Specification MOS(A)/CV2319	SECURITY		
Issue 2 Dated 8.9.54	Specification	Valve	
To be read in conjunction with K1001	UNCLASSIFIED	UNCLASSIFIED

Amendment A Nol.

AMENDMENT No. 2

August 1967 T.V.C. for R.R.E. ELECTRONIC VALVE SPECIFICATIONS
SPECIFICATION CV 2319, ISSUE 2 DATED 8.9.54
AMENDMENT No 3

Drawing on Page 3

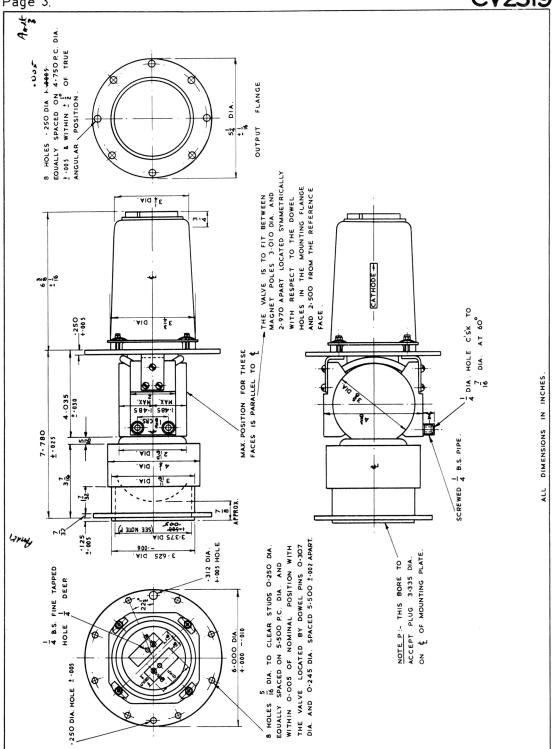
Side elevation - Amend dimension of bore diameter to read

3.375 dia + .005 (See Note

VIEW OF OUTPUT FLANGE (top left hand side of page)

The first line of the text states "8 holes, .250 dia + .0005"

amend this to read "8 holes, .250 dia + .005"
